# Highlights of HB 2001 Draft Code Amendments 7/7/21

- Minimum Lot Sizes
- Off-Street Parking Minimum
- Floor Area Ratio (FAR)
- Cottage Clusters
- Reduction of Compatibility Standards

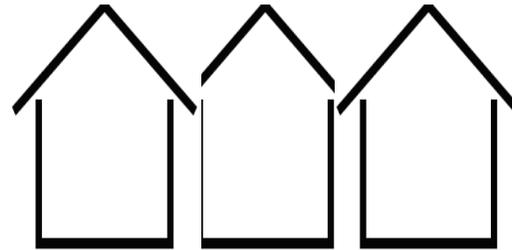
## Reasons for concern:

- ✓ HB 2001 doesn't mandate this increase in the FAR. This change was driven by the designers / architect / builders on the committee.
- ✓ This proposed code change in table 2.1.700 states any new residence (Single-family, duplex, triplex, quadplex and Townhouse) could be 1.5 times the size of the existing residences on 4,000 sq.ft. lots. If the lot is 6,000 sq.ft., over 2.5 times the size (which is common in existing neighborhoods).
- ✓ Increasing the size of this new residence doesn't guarantee its affordability. It encourages higher pricing.
